SUBJECT: AMENDMENT NO. 131 TO PROVISIONAL OPERATING LICENSE NO. DPR-20:
PRESSURE-TEMPERATURE LIMITS AND LOW-TEMPERATURE OVERPRESSURE
PROTECTION (TAC NOS. 72889 AND 71526)

UNITED STATES
NUCLEAR REGULATORY COMMISSION
WASHINGTON, D. C. 20555
April 26, 1990

Amendment No.131
License No. DPR-20

ATTACHMENT TO LICENSE AMENDMENT NO. 131

FIGURE 3-1

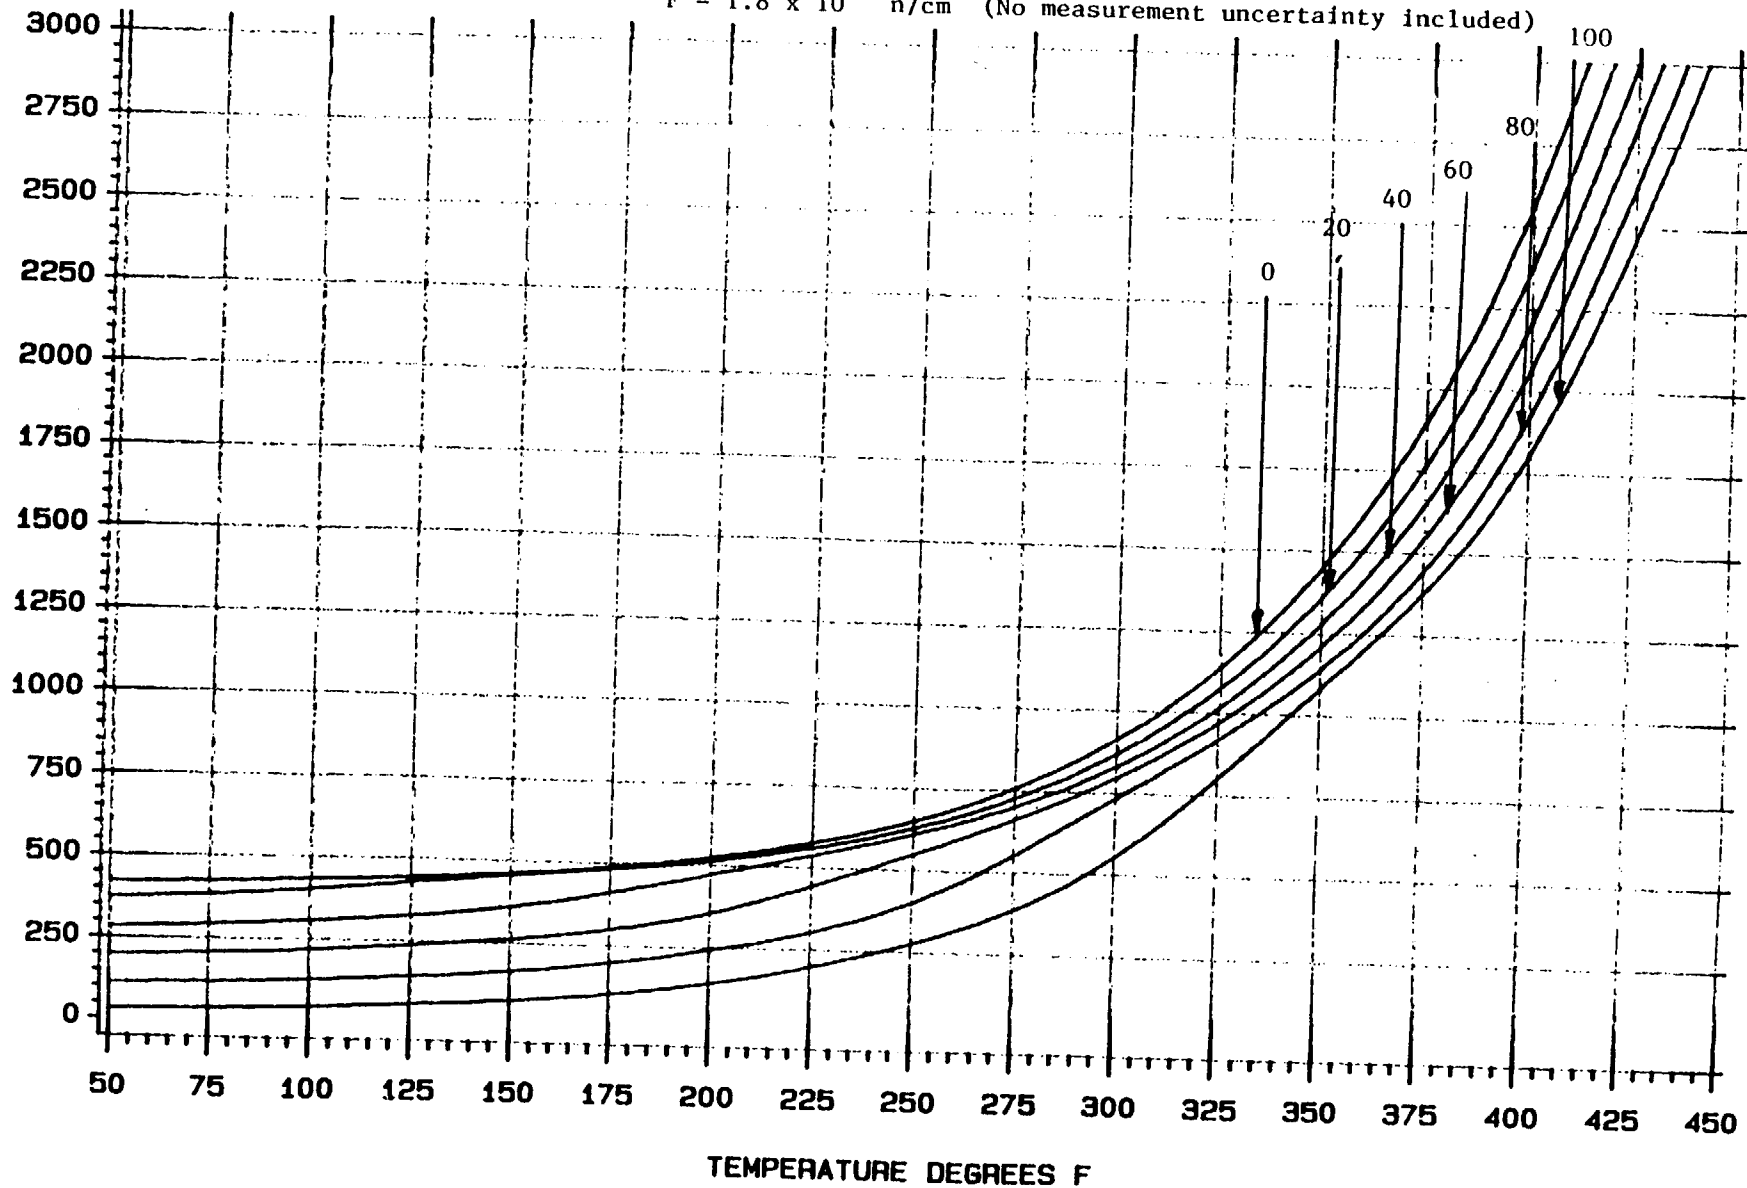
- a. Allowable combinations of pressure and temperature for any heatup or cooldown rate shall be below and to the right of the applicable limit line as shown on Figures 3-1 and 3-2. The average heatup or cooldown rate in any one hour time period shall not exceed the heatup or cooldown rate limit when one or more PCS cold leg is less than the corresponding "Cold Leg Temperature" below. /

d. Before the radiation exposure of the reactor vessel exceeds the exposure for which the figures apply, Figures 3-1, 3-2 and 3-3 shall be updated in accordance with the following criteria and procedure:

CPCo proposed changes of Technical Specifications 3.1.1h, 3.1.8, 3.3.2g, 4.1.1c, 4.6.1b, Figure 3-4 and their associated bases sections reflect the above discussed LTOP system modifications and the heatup and cooldown rates identified by the updated Figures 3-1, 3-2, and 3-3. The staff finds that they are reasonably conservative and acceptable.

FIGURE 3-3 PALISADES PRESSURE AND TEMPERATURE LIMITS FOR HYDRO

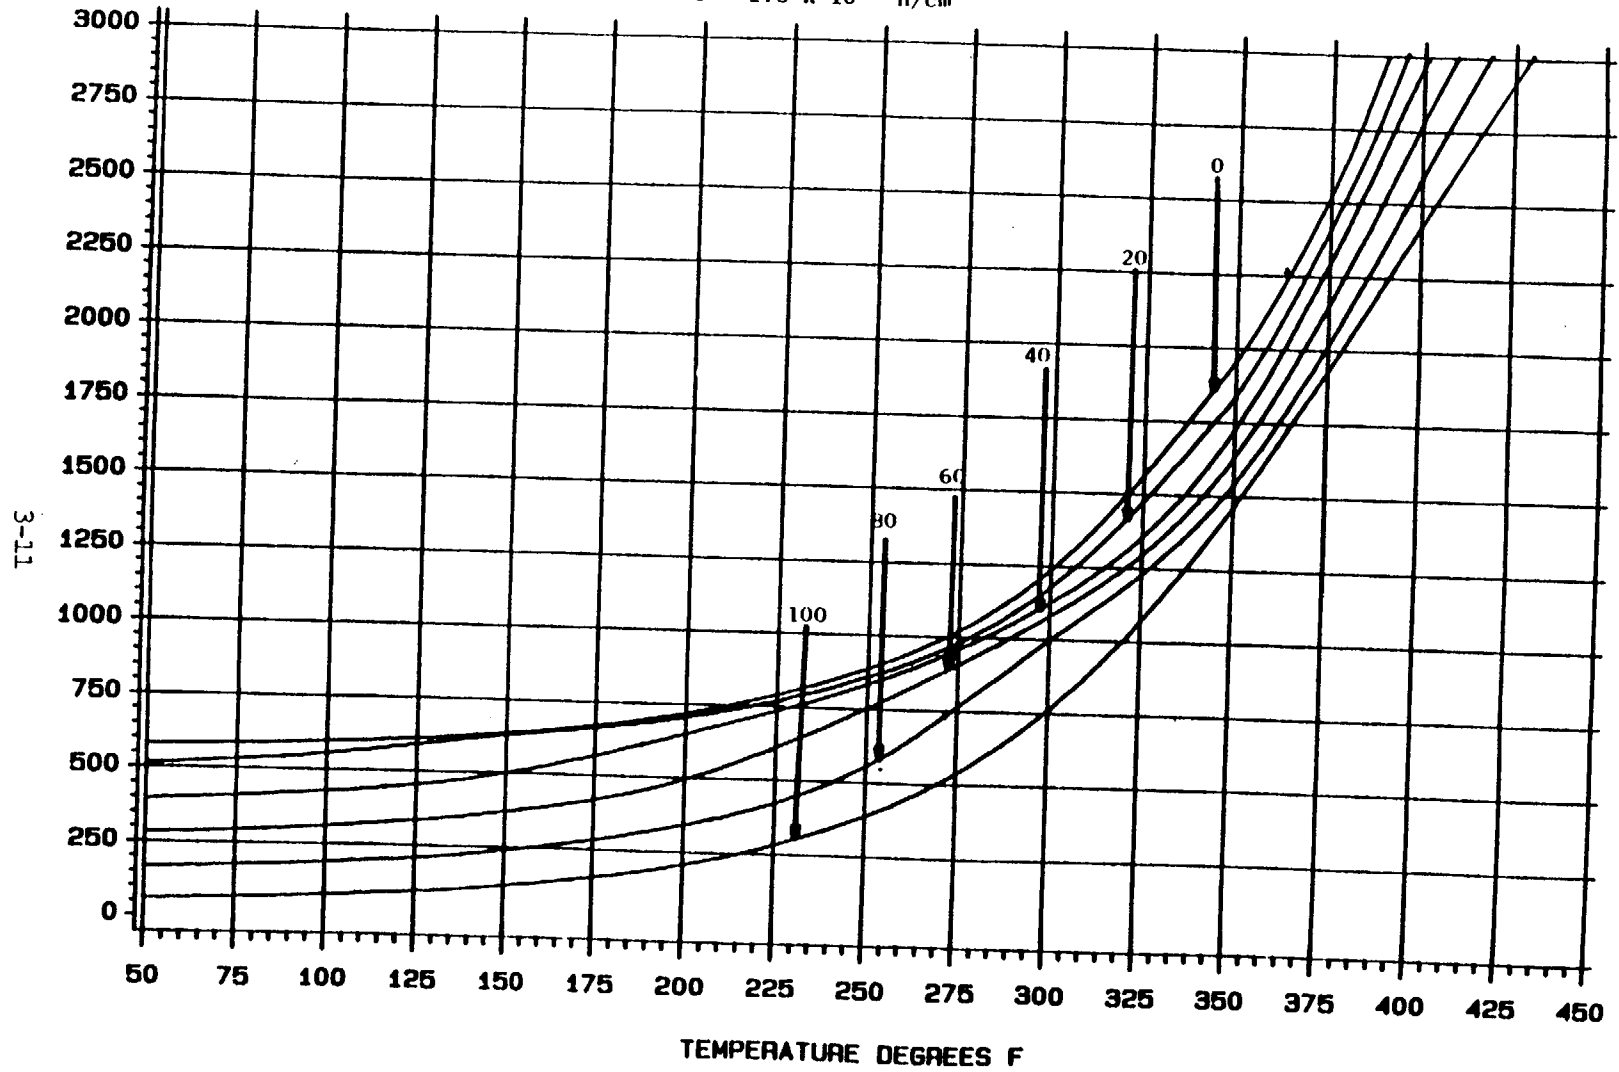
- b. Allowable combinations of pressure and temperature for inservice testing during heatup are as shown in Figure 3-3. The maximum heatup and cooldown rates required by Section a. above, are applicable. Interpolation between limit lines for other than the noted temperature change rates is permitted in 3.1.2a. /

Figure 3-4

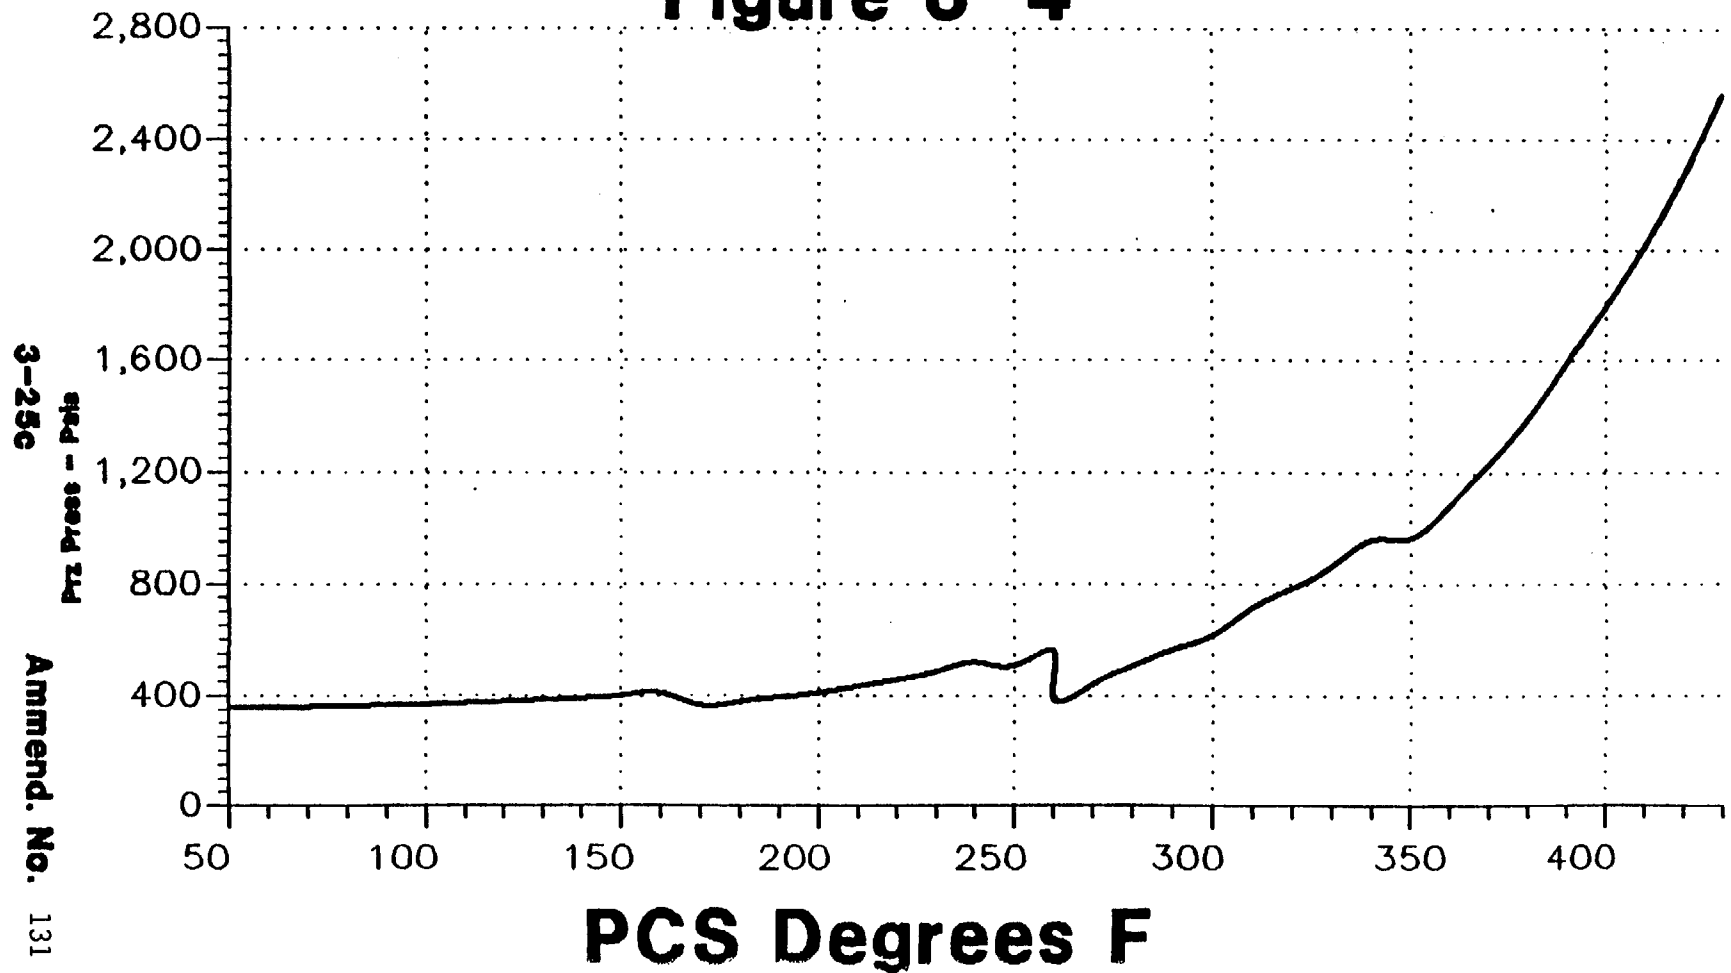
Two power operated relief valves (PORVs) with a lift setting below and/or to the right of the curve in Figure 3-4 shall be operable. /

Assurance that the Appendix G limits for the reactor pressure vessel will not be violated while operating at low temperature is provided by the variable setpoint of the Low Temperature Overpressure Protection (LTOP) system. The LTOP system is programmed and calibrated to ensure opening of the pressurizer power operated relief valve (PORV) when the combination of primary coolant system (PCS) pressure and temperature is above or to the left of the limit displayed in Figure 3-4. That limit is developed from the more limiting of the heating or cooling limits for the specific temperature of the PCS while heating or cooling at the maximum permissible rate for that temperature. The limit in Figure 3-4 includes an allowance for pressure overshoot during the interval between the time pressurizer pressure reaches the limit, and the time a PORV opens enough to terminate the pressure rise. LTOP is provided by two independent channels of measurement, control, actuation, and valves, either one of which is capable of providing full protection. The actual setpoint of PORV actuation for LTOP will be lowered from the limit of Figure 3-4 to allow for potential instrument inaccuracies, measurement error, and instrument drift. This will ensure that at no time between calibration intervals will the combination of PCS temperature and pressure exceed the limits of Figure 3-4 without PORV actuation.

CPCo proposes to replace the existing PORVs and block valves with larger valves. The LTOP system will be programmed and calibrated to ensure opening of the PORVs when the combination of reactor coolant pressure and temperature is above or to the left of the limits displayed in Figure 3-4 of the proposed Technical Specifications. This limit curve is developed from the more limiting of the heatup and cooldown limits for the specific PCS temperature while heating or cooling at the maximum permissible rate for that temperature. The limit in Figure 3-4 includes an allowance for pressure overshoot during the interval beginning when a PORV opens to terminate the pressure rise and when the PCS pressure reaches the limit. Either one separately of the two PORVs is sufficient to provide LTOP. The actual PORV lift setting will be lowered from the limit of Figure 3-4 to allow for potential instrument inaccuracies, measurement error, and instrument drift.
